**Re: McPhillamys Gold Project (SSD 9505) – Response to request for additional information**

This letter provides a response to the request for additional information (RFI) from the NSW Department of Planning, Industry and Environment (DPIE), dated 27 October 2020, in relation to the McPhillamys Gold Project (the project). Each request is reproduced in the box and a response provided below.

**Figure 1.1 Indicative open cut pit refill schedule**

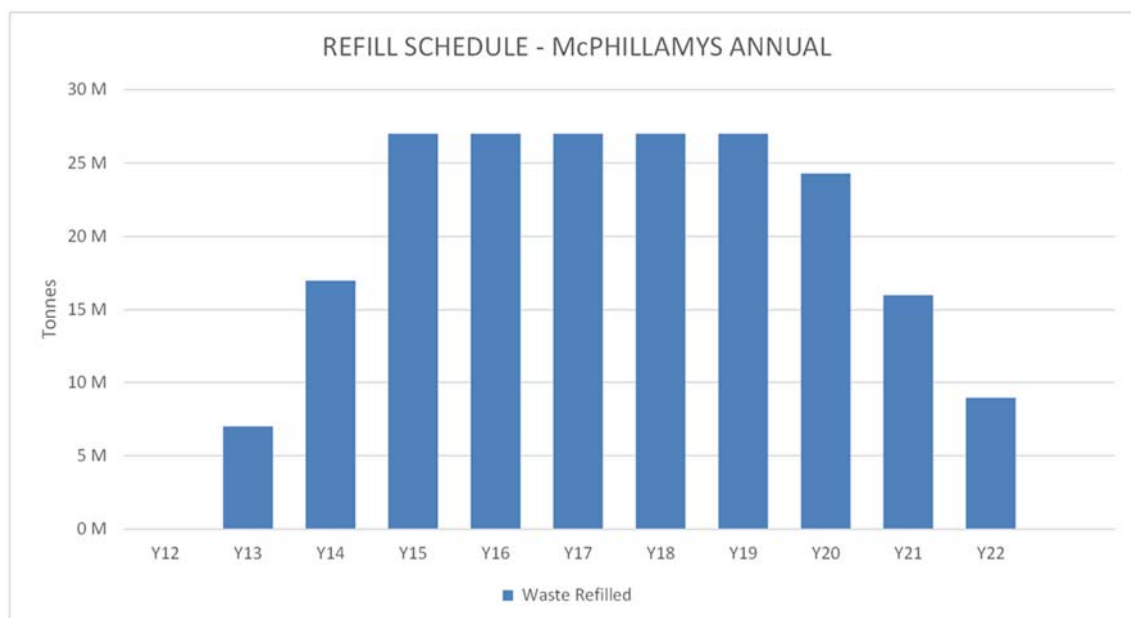
Please provide further information about site rehabilitation and options for final landform design, including reasonable and feasible options to (wholly or partially) fill the open cut pit, and the associated costs and benefits.
--

To illustrate the above, an indicative schedule has been developed to backfill the void once mining is complete, as presented in Figure 1. This schedule is based on similar average mining rates to that assumed for ore extraction in the Amendment Report (EMM 2020a). Infill rates are limited during years 13 and 14 by the available working room at the base of the open cut pit.

As shown, it would take approximately 10 years to refill the void with material from the waste rock emplacement, effectively doubling the life of the Project. The backfilling operation would involve disturbing the established rehabilitated areas of the waste rock emplacement, including the southern amenity bund, removing the visual screening of earthworks that this provides.

McPhillamys Gold Project  
Response to DPIE RFI  
Figure 5.1

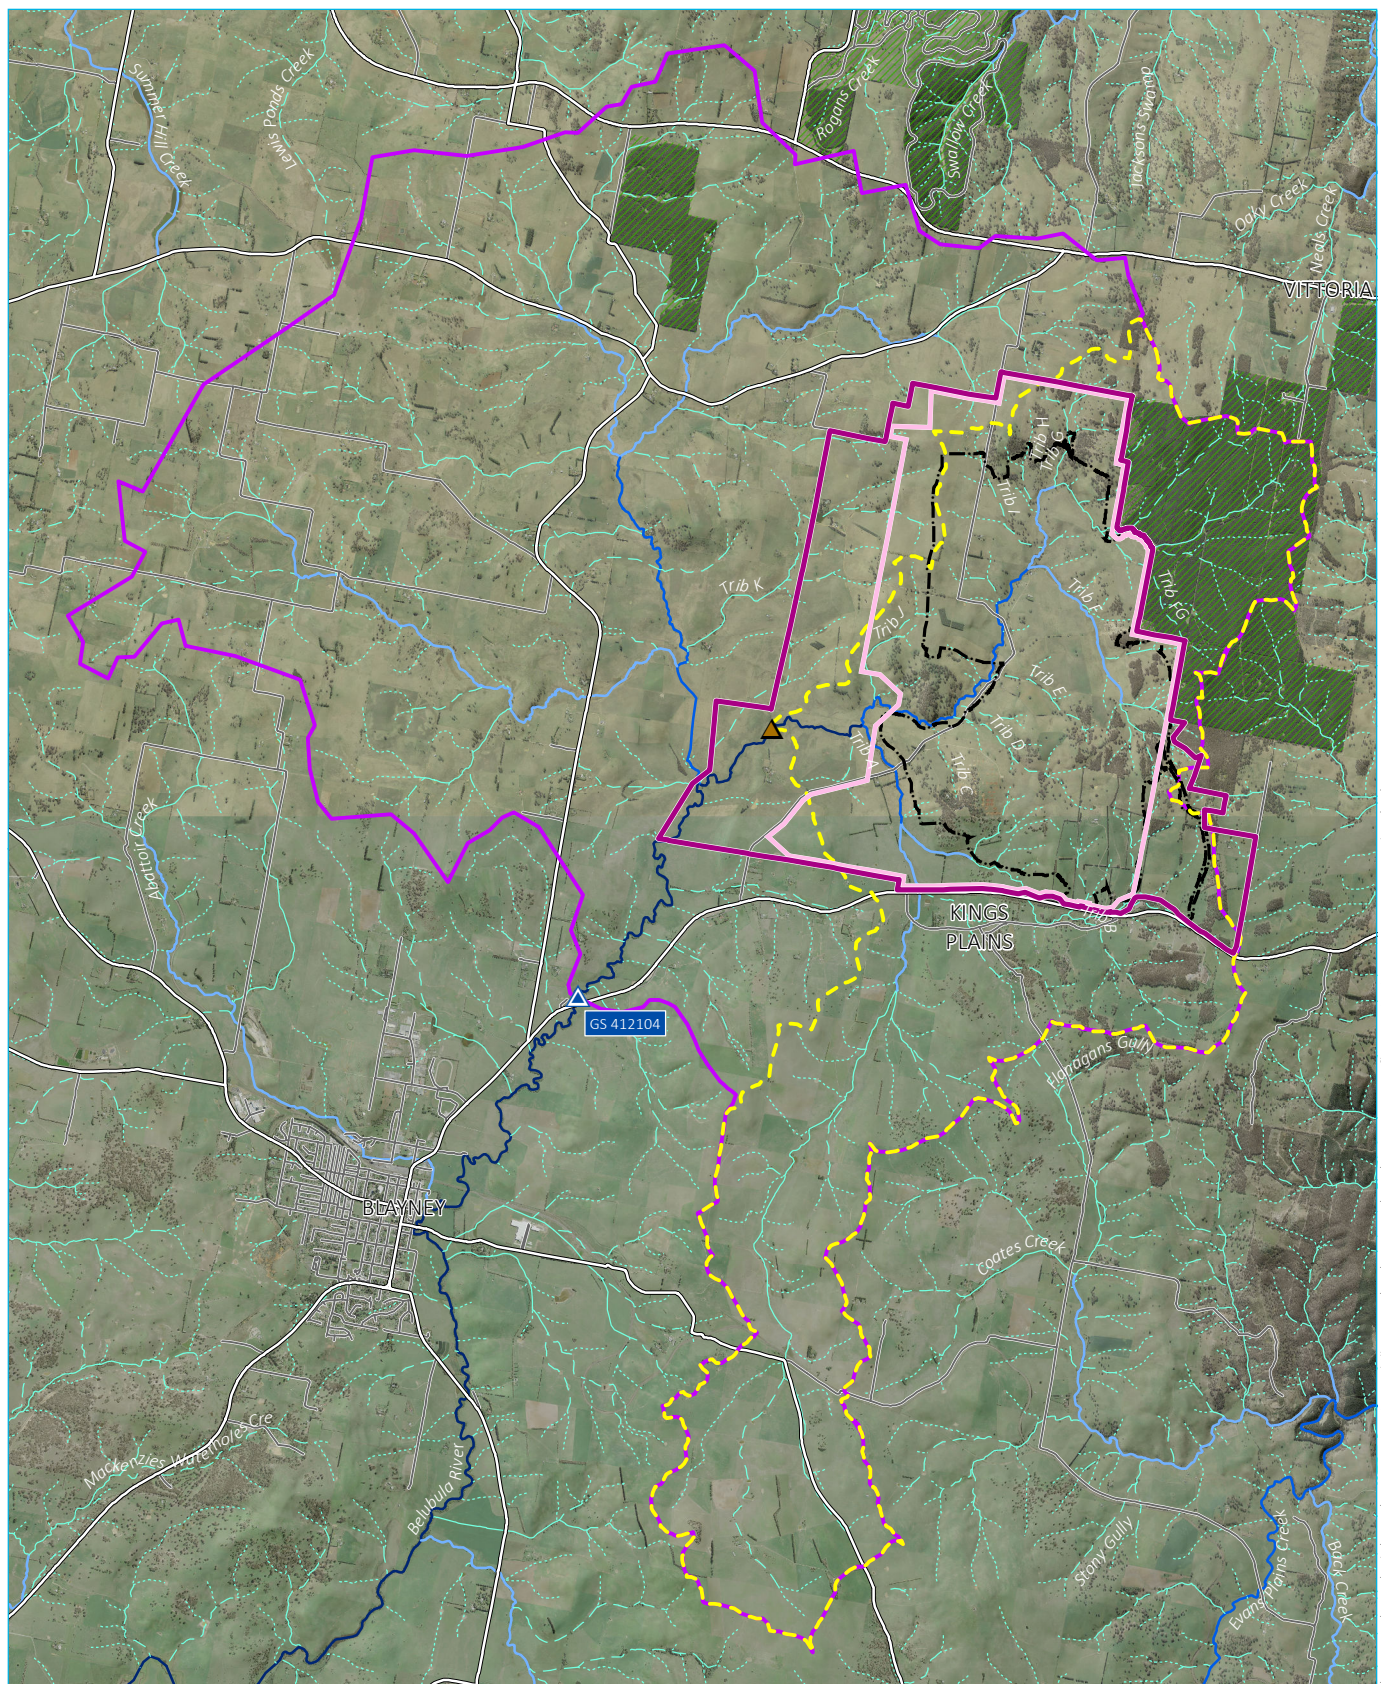
Please provide further information about spring flow and interactions with the Belubula river pre-mining, including validation and analysis of flow duration curves, and flow information from the V-notch weir installed in late 2019 to support analysis of spring flow contribution.
---

As part of the assessments, EMM and HEC have reviewed available streamflow data from the gauging station (Belubula River at Upstream Blayney, GS 412104) that was located at the Mid Western Highway and the v-notch weir monitoring station (monitoring site SWFM05). The assessments involved reviewing streamflow data to estimate baseflow (groundwater discharge) at the two locations and to review flow persistence during the monitoring periods. The flow monitoring locations (GS 412104 and SWFM05) are presented on Figure 5.1.

Regis installed a v-notch weir downstream of the confluence of the Belubula River and Trib A in January 2020. The weir is located downstream of the project disturbance footprint and the mining lease application area (Figure 5.1). The weir was commissioned in March 2020, whereafter flow monitoring commenced.
